3.2 24 Lyndhurst Crescent, Hawthorn - alterations and additions to a heritage dwelling - amended proposal at VCAT (P22/0415)

REPORT TO CONSIDER REVISED POSITION ON PLANNING PERMIT OUTCOME

Application Number	PP22/0415 (VCAT Reference: P1466/2023)
Planning Officer	Daniel Murphy
Property Address	24 Lyndhurst Crescent, Hawthorn
Zoning	Clause 32.09 - Neighbourhood Residential Zone Schedule 3
Overlays	Clause 43.01 - Heritage Overlay Schedule 155
Particular Provisions	None
Permit Triggers	Clause 43.01-1 (HO) of the Boroondara Planning Scheme, a permit is required to: <ul style="list-style-type: none"> • Demolish or remove a building. • Construct a building or construct or carry out works.
Aboriginal Cultural Heritage	No
Covenant	No
Potential Overland Flow?	No
Ward	Glenferrie
Number of Objections Received	22 objectors were received following public notification. Four (4) statements of grounds have been received by Council, including a joint statement of grounds. All four (4) objectors have elected to participate as parties to the VCAT proceedings.
Plans Assessed in this Report	The plans before Council are the VCAT amended plans circulated on 2 April 2024 identified as: Drawing no. TP01-T

Above - Demolition Plan (TP02, 2 April 2024)

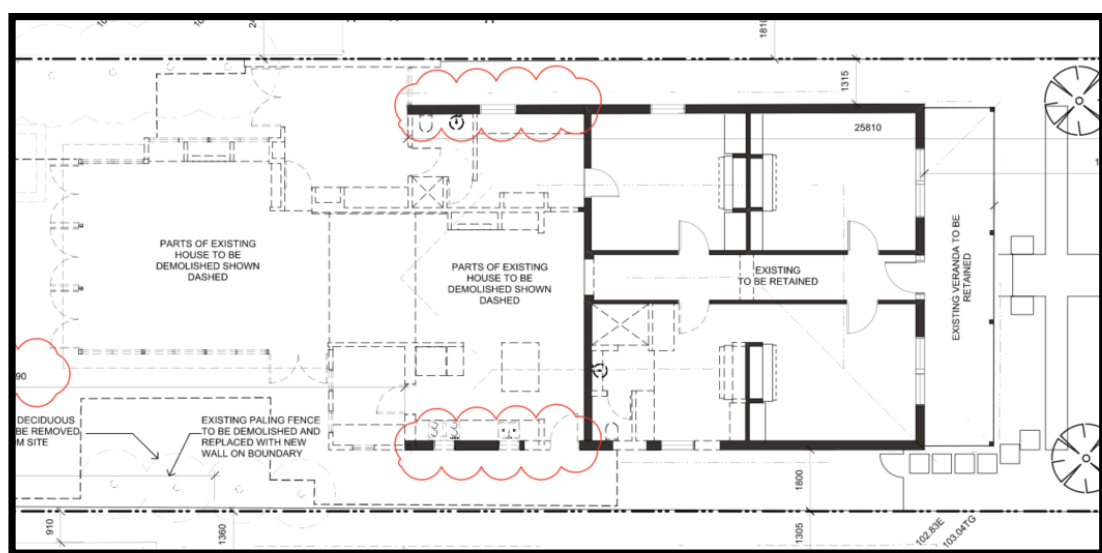
The extent of demolition in the amended plans has been significantly reduced in scope and is limited to the following elements:

- Southern portion of wall.
- Return end hipped roof forms.
- Portion of internal roof valley.
- Non-original extension.
- Openings filled in (East Elevation)

These elements are not generally visible from the street and the appreciable form of the return ends are retained, where visible from Lyndhurst Crescent. This appreciable and contributory roof form being retained is a positive heritage outcome. The presentation and consistency of the roof forms along Lyndhurst is important in understanding the heritage dwelling and precinct.

The extent of demolition complies with Council's Heritage Policy at Clause 15.03-1L and is supported by Council's Heritage Advisor.

Above – Proposed East Elevation (2 April 2024)

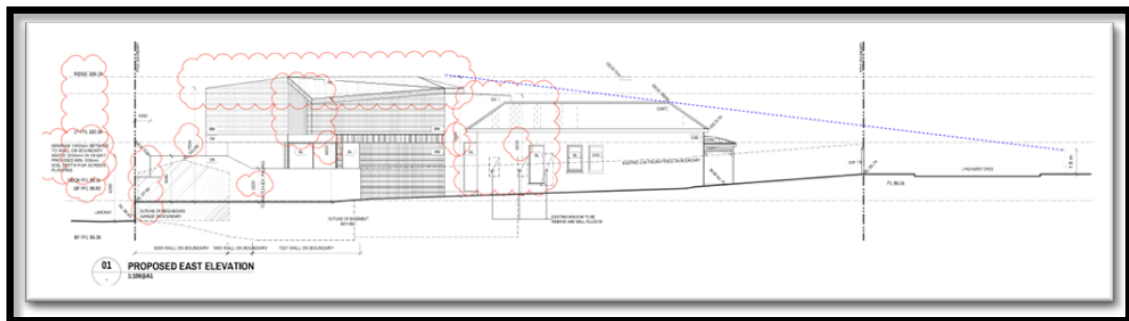
The ground floor siting extends beyond the existing setbacks of the host building. The western siting is built to match existing wall on boundary with the adjoining property. Given the slope of the site, the ground floor addition will have limited visibility and sits below the eaves of the existing building, which ensures it reads as a subservient, secondary element.

As can be seen from the proposed eastern elevation above, the proposal meets Council's 'sight line' test for contributory graded dwellings under Clause 15.03-1L.

04 PROPOSED NORTH ELEVATION
1:100@A1

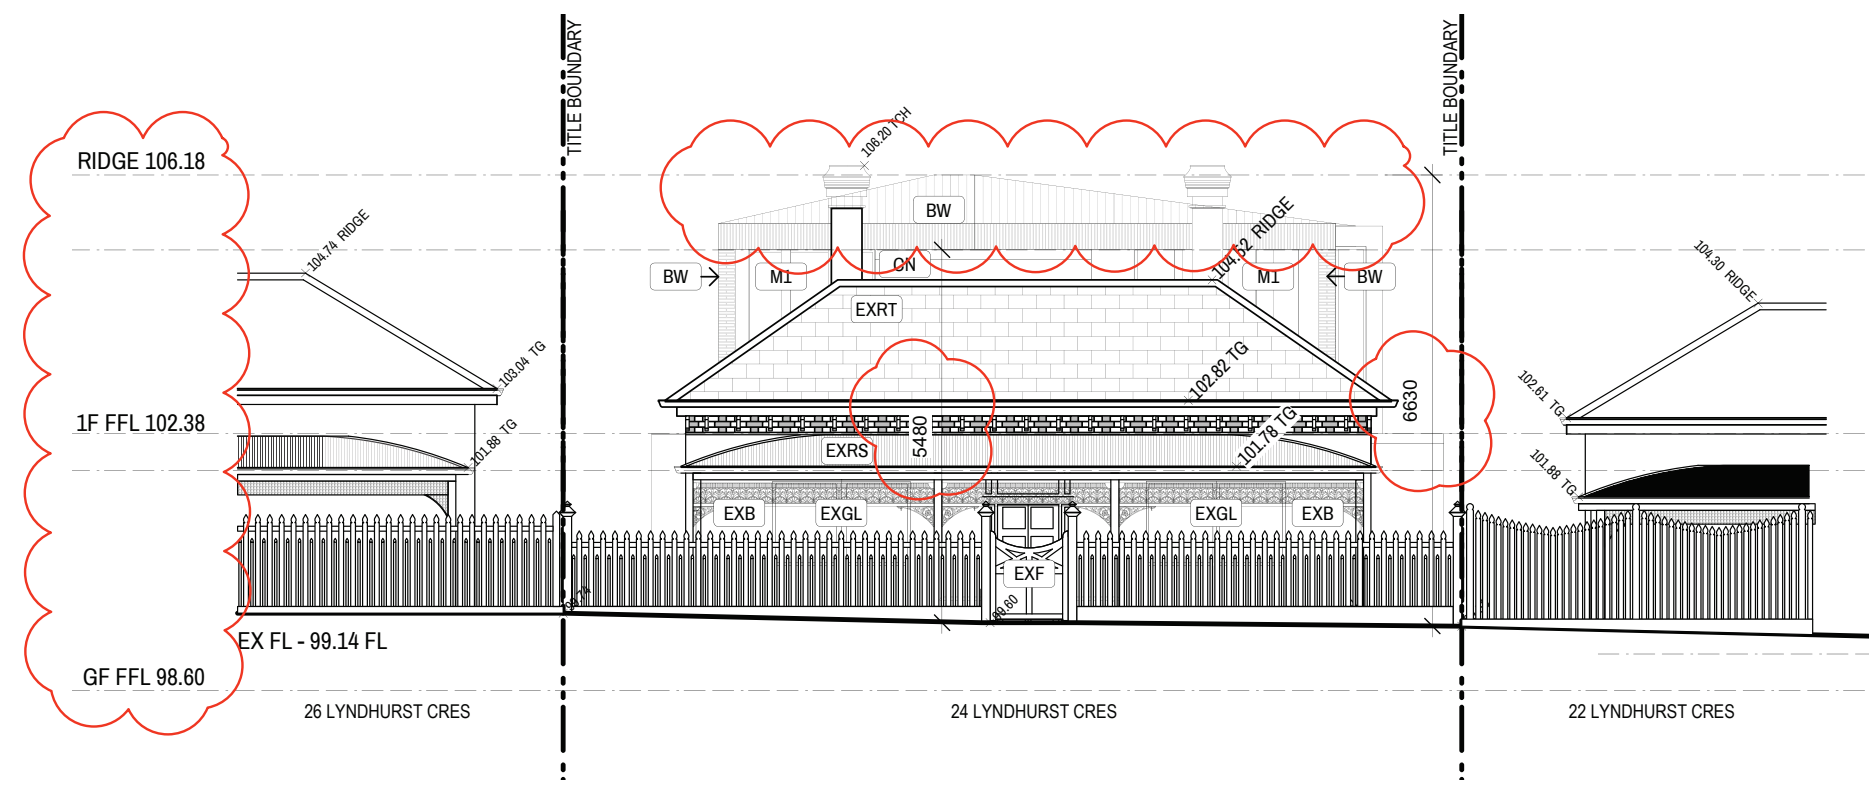
8	<i>The ground floor built form of the addition be clearly depicted in the proposed northern elevation in the next iteration of drawings</i>	<i>The proposed northern elevation (at Drawing TP09) does not appear to show the ground floor built form extending to the property boundary to the west.</i>	<i>Actioned</i>

Drawing Title	Drawing No.	Rev.
PROPOSED ELEVATIONS	TP10	-
Scale 1:100 @ A1 / 1:200 @ A3	Date	
	02.04.2024

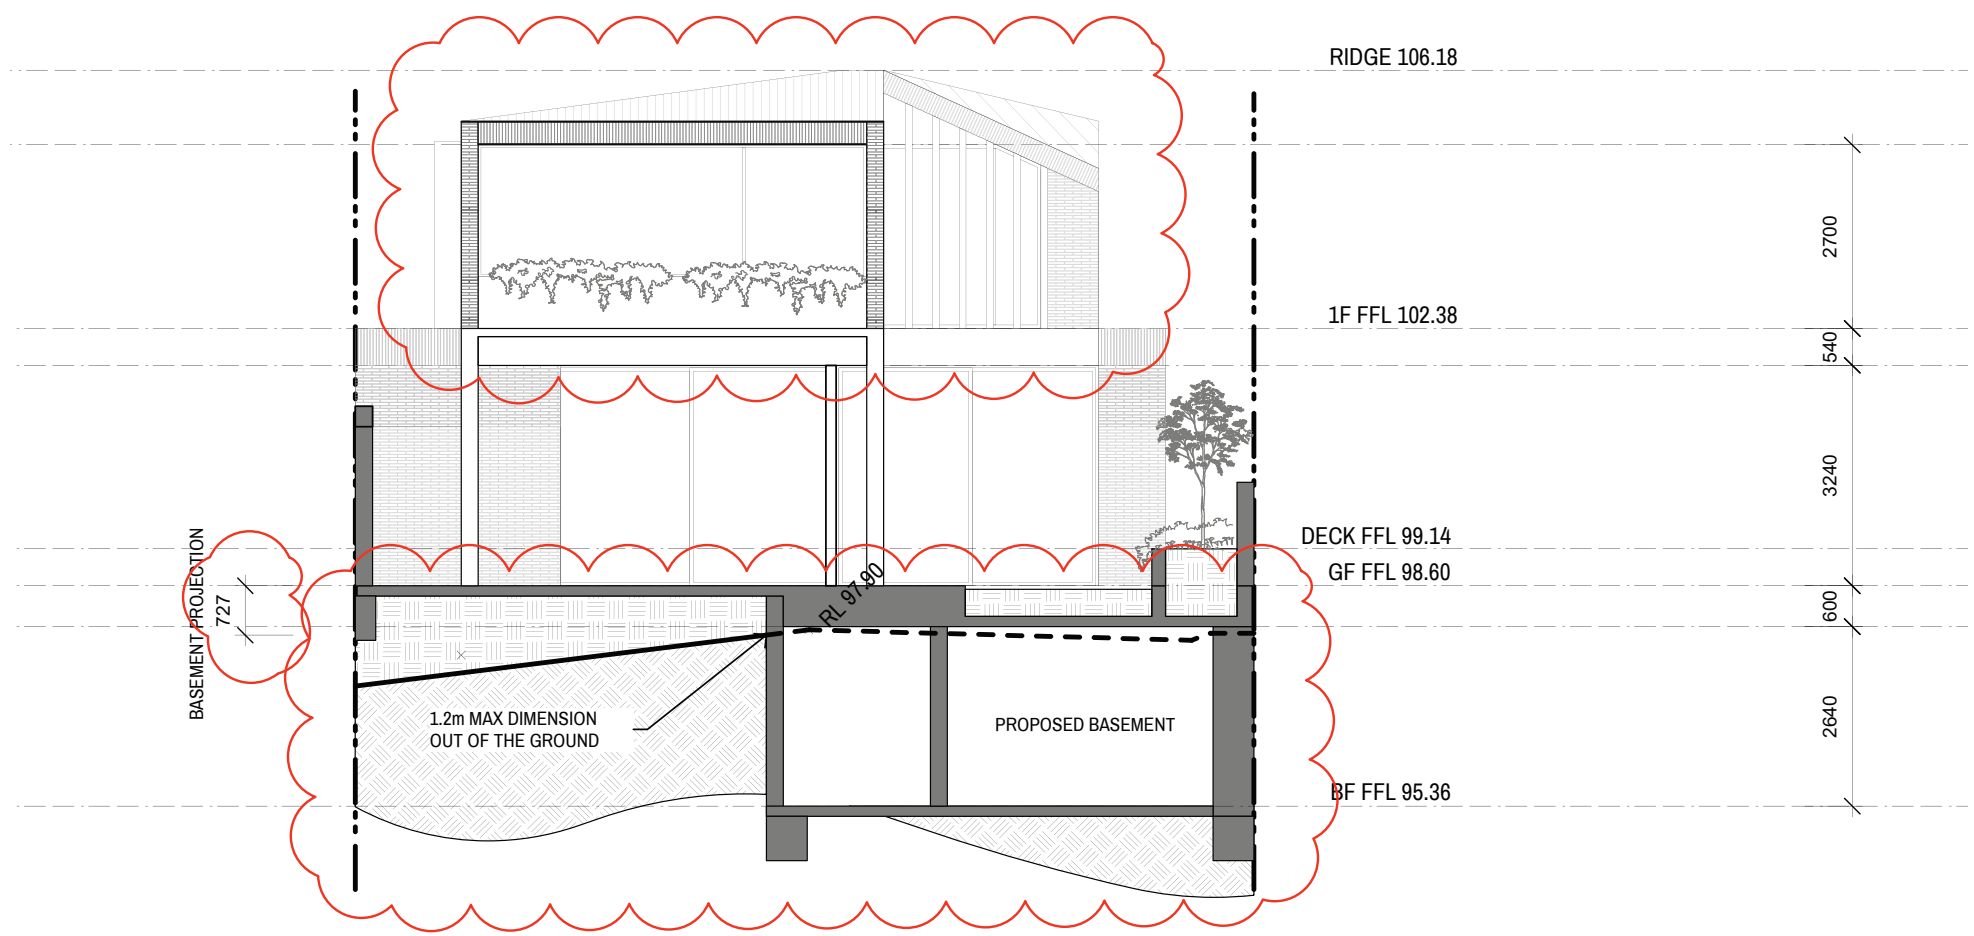
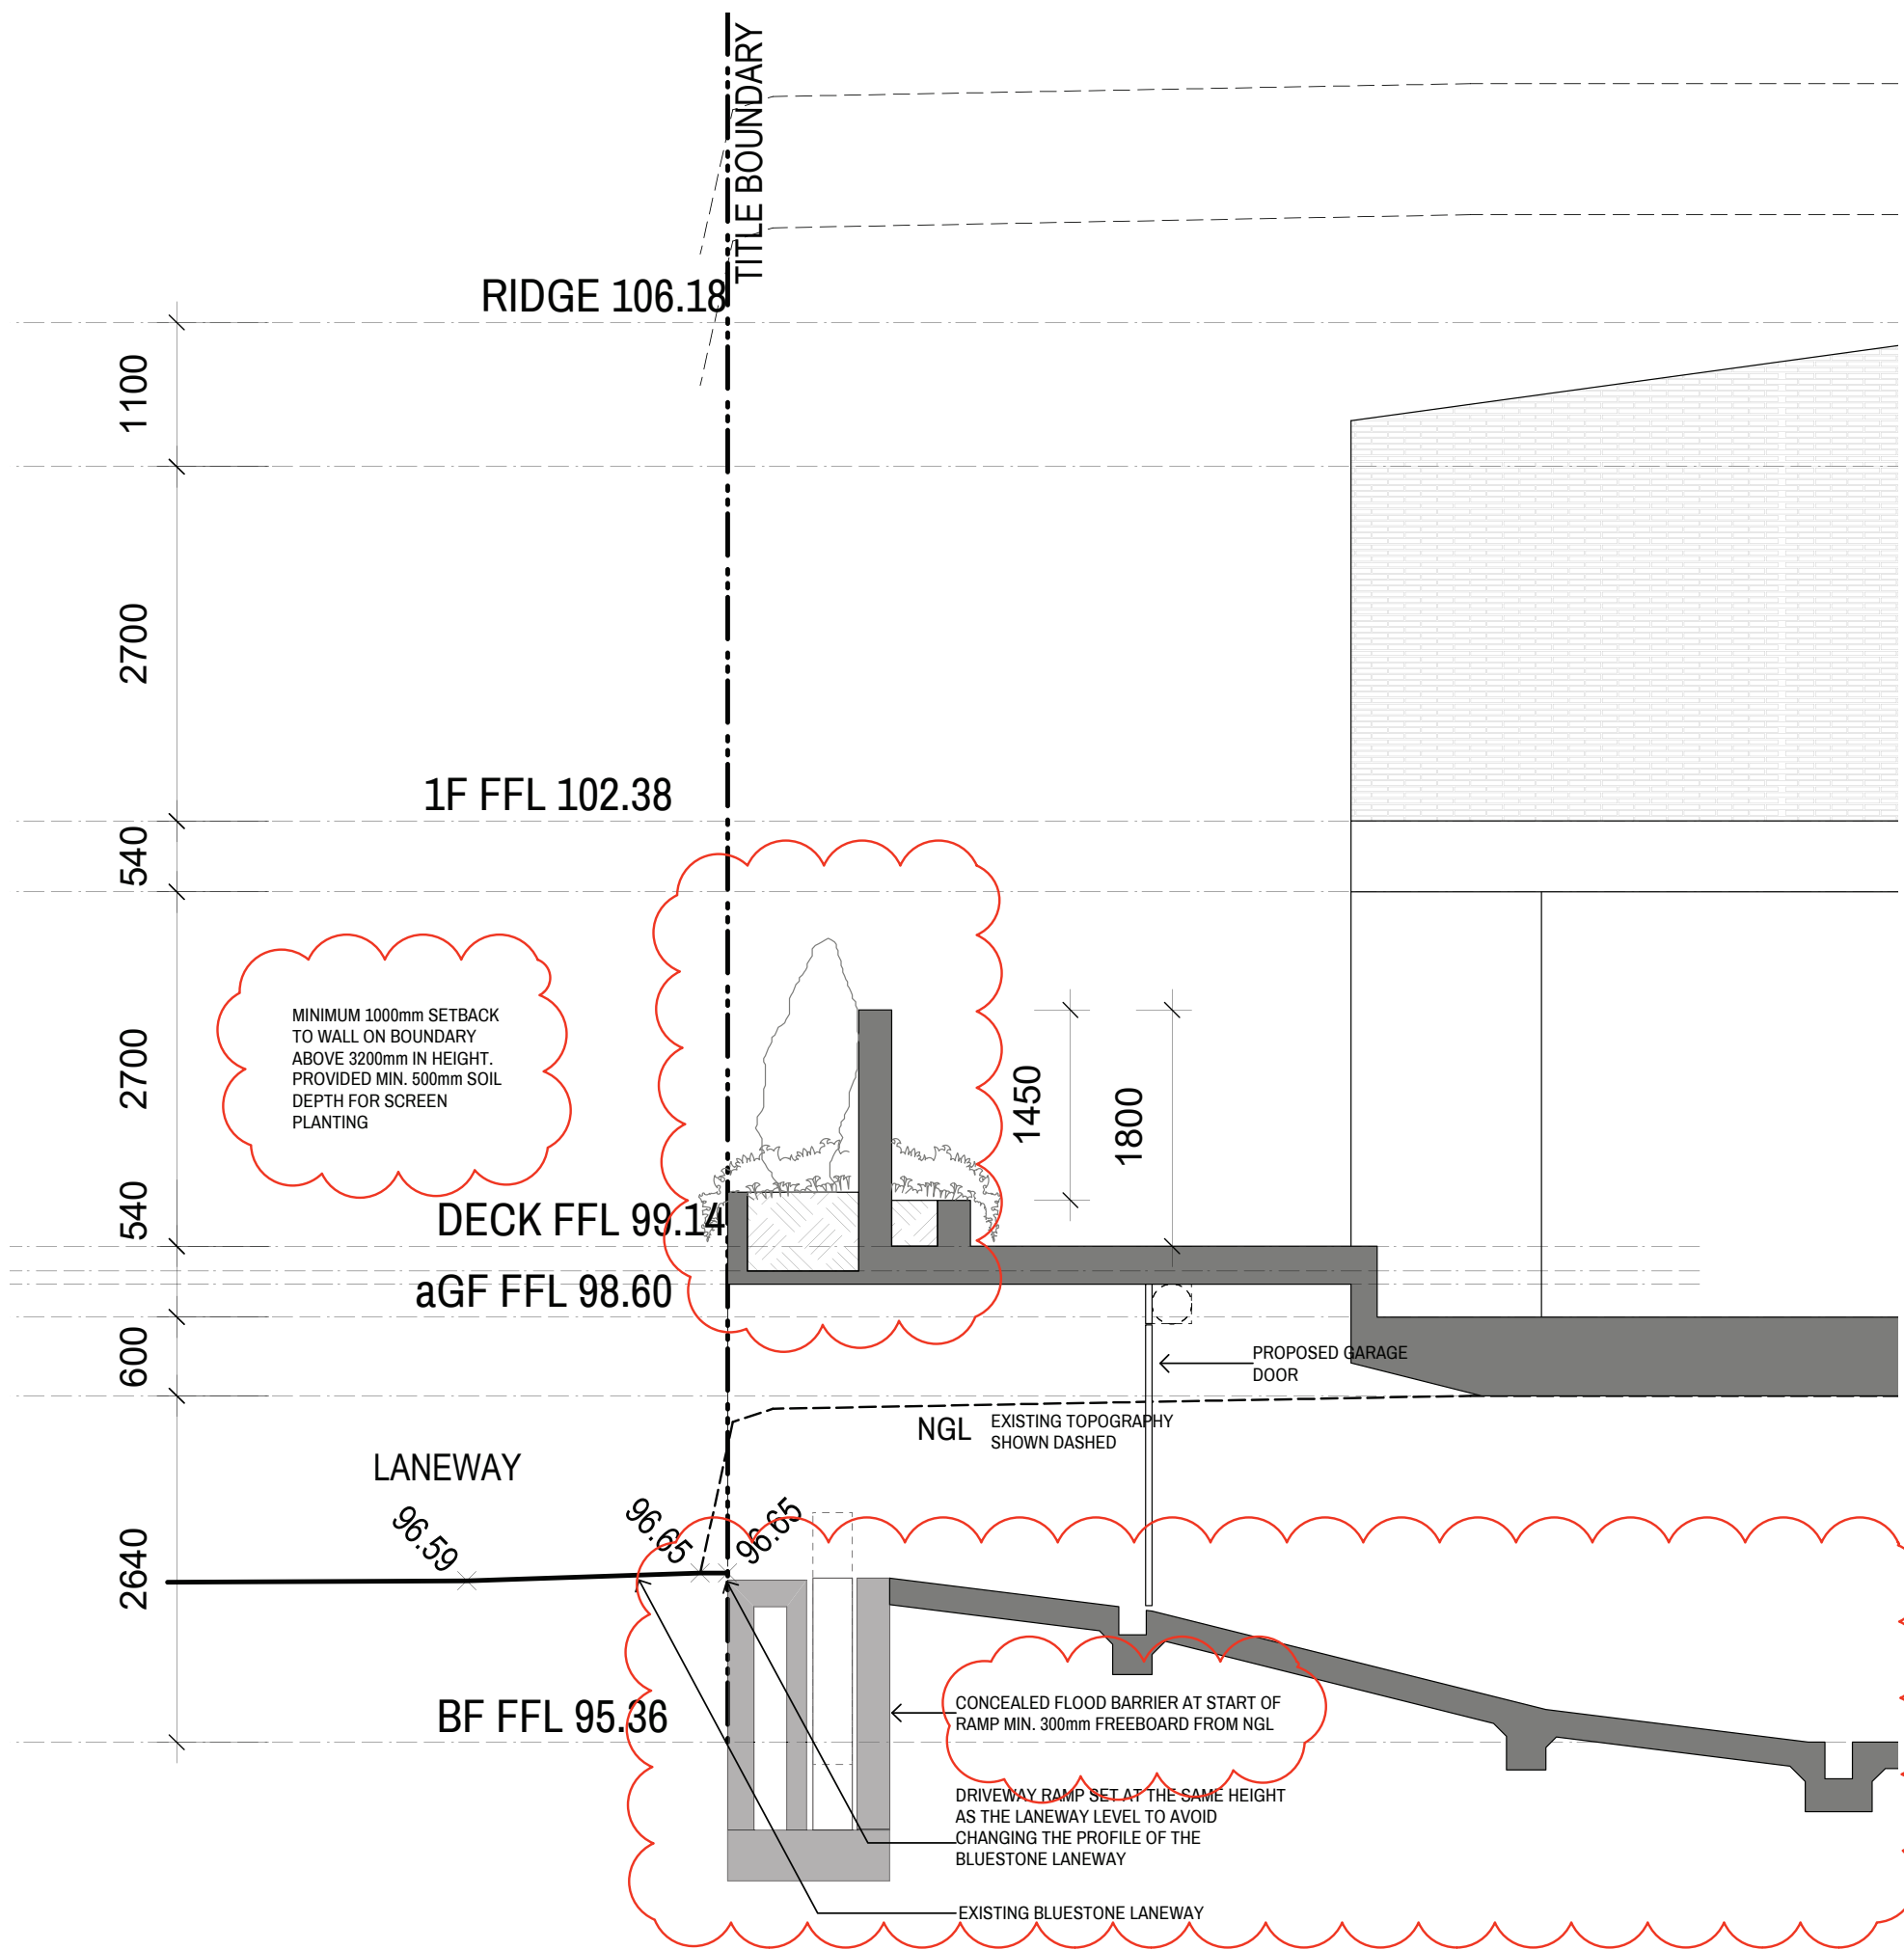
The proposed sheer 4m-4.5m (measurements vary in the drawings) rendered concrete wall is substantially out of keeping with existing boundary arrangements

to the laneway and would risk dominating the bluestone laneway. It is recommended that this be reduced in height to a maximum of 3m, with any portion above that height set back substantially. **A setback has been incorporated above 3.2m. This is acceptable.**
